SUBJECT: RM Fan Housing Bolt Torque

NUMBER: SB-0243a

Certain RM (RegenX) sweepers may have Fan Housing Bolts that are improperly tensioned. FSO 1140232 must be installed on all affected sweepers.

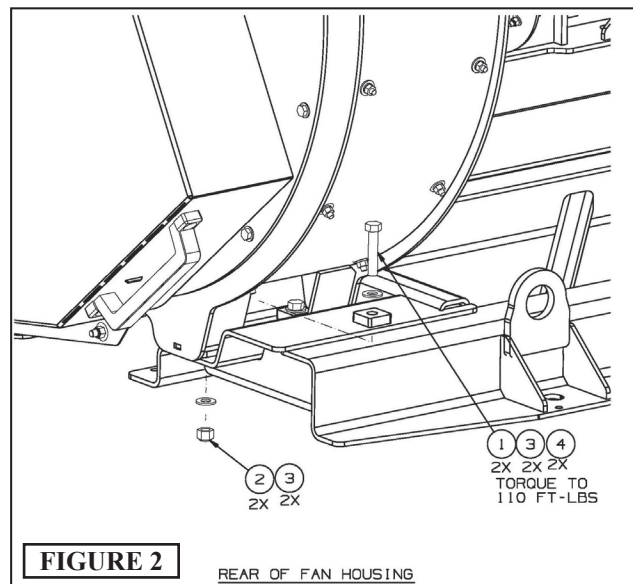
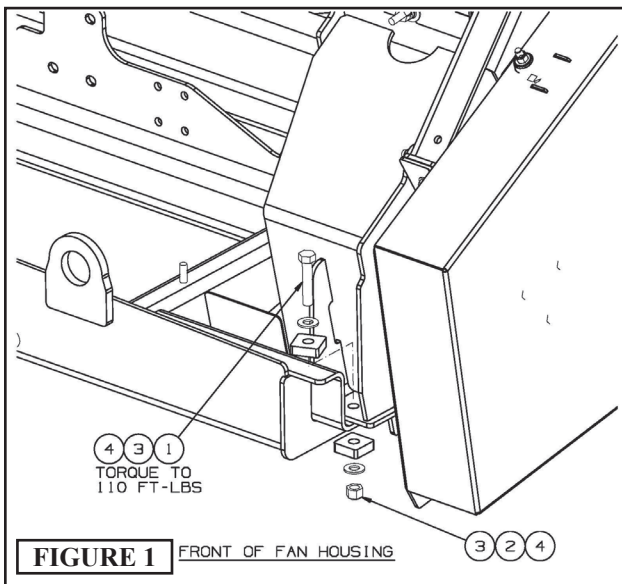
FSO 1140232 provides parts and instructions to update the Fan Housing Assembly Retention. Grade 5 hardware is replaced with new Grade 8 hardware and new spacers must be installed. Bolts must be tightened to 110 lb-ft.

1. Order FSO 1140232 for all affected units.
2. Install FSO 1140232 as instructed in the drawing supplied with the kit. (reference FIGURES 1&2)

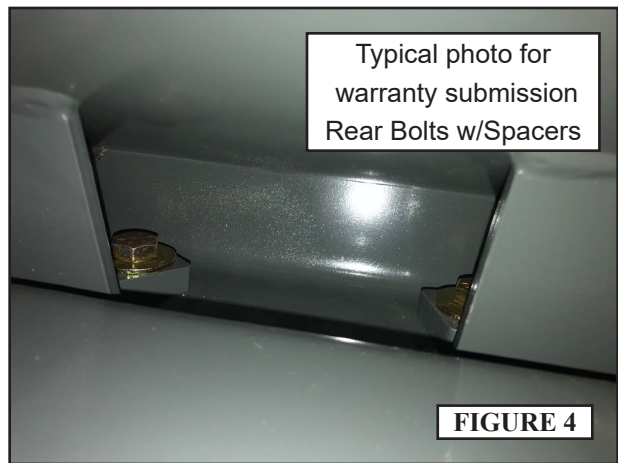
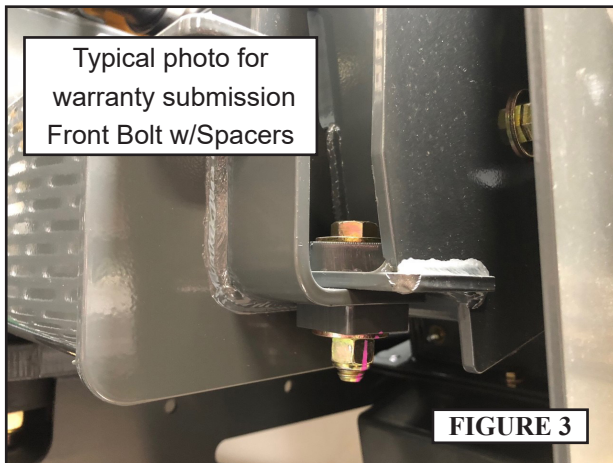
Submission must include photo of the completed installation for each unit. See typical photos (FIGURES 3 and 4).
